As an owner of property in the Millers Point Community, I strongly object to the modification of the development to Fort Street Public School.

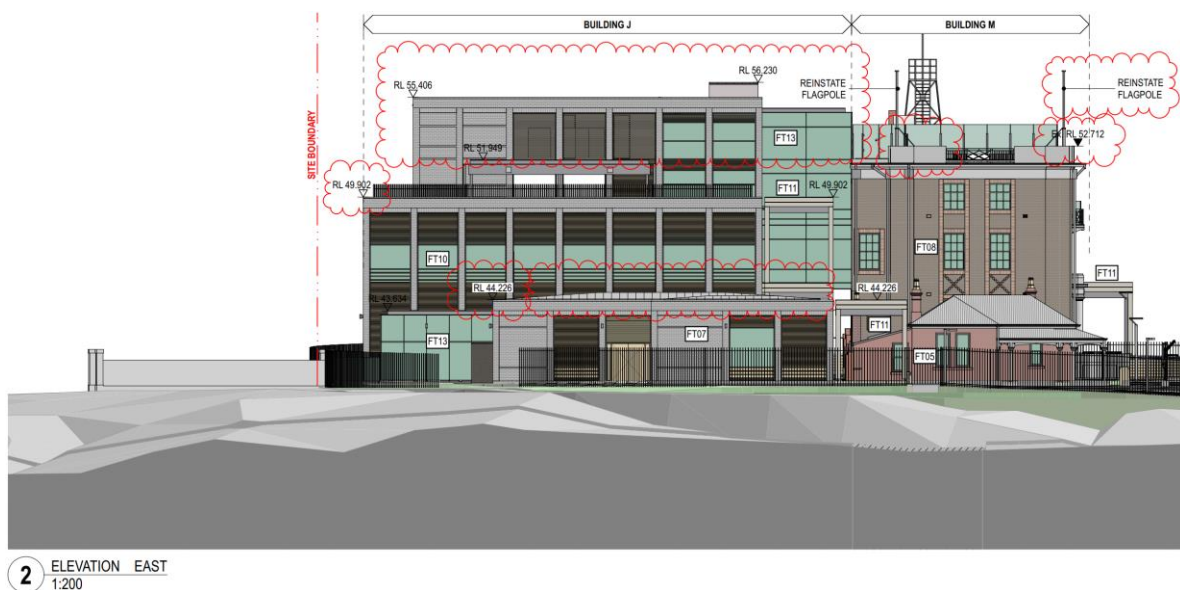
I can see no advantage to the school to disregard the advice of Curio Project's Conservation Plan dated 17/3/2020 located in this link:

There are key principles with which Curio have stated in this plan that all future developments would have to comply. The very first modification to the development does not comply with these principles. Specifically, I refer to these 3 as a minimum not complied with:

1. Policy 21.4 which states "Any future development should retain the general bulk and massing character of precinct (i.e. complement single storey Messengers Cottage as well as three stories of MET)".
2. Policy 25.3 which states "Maximum heights of new buildings should not exceed those of the existing heritage items to which they are locationally and visually related."
3. Policy 25.5 which states "The Bureau of Meteorology should remain as a dominant building on site (both in height, and architectural form)".

How can Curio Projects on behalf of School Infrastructure NSW say that the increased building height of the Building "J" is compliant to these policies when it is proposed that the new height is well above the parapet of the Met Building? This can be seen in the following diagrams taken from the modification documents where building J is much larger, the general bulk much bigger and it very clearly exceeds the height of the Met building, leaving the Met building to no longer be the most dominant building on site in terms of both height and architectural form.
